Subject: Mallard North Landfill

Response to Comments on the Groundwater Evaluation Report

# Mallard Lake Preserve (2008 Aerial)

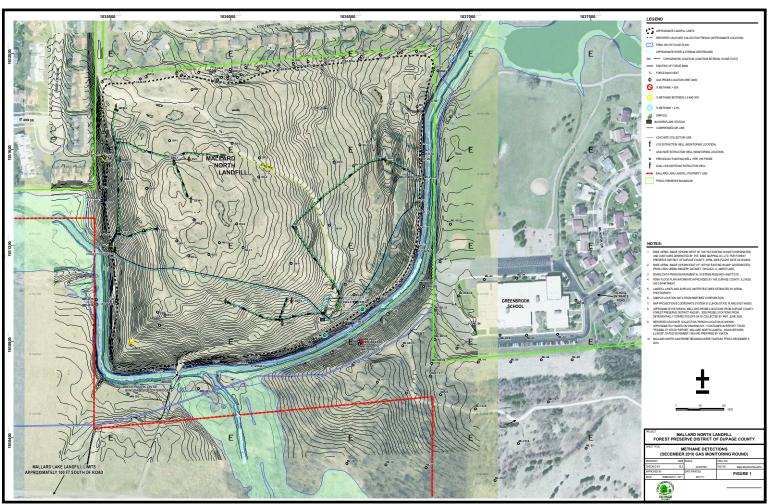
The groundwater contamination caused by the landfill should be (at a minimum) controlled and contained within the District's property boundary.

The process of defining the extent of groundwater contamination is underway; one of the four baseline groundwater monitoring events has been completed. The relationship between the extent of groundwater contamination and the District's property boundary will be evaluated as part of the

baseline groundwater monitoring. The property boundary was discussed during the February 10, 2001 meeting and maps showing the property boundary were transmitted by the District to U.S. EPA and IEPA via e-mails dated February 10 and 11, 2011. Updated copies of the maps were transmitted to U.S. EPA and IEPA via e-mail on February 15, 2011 (see Attachment A).
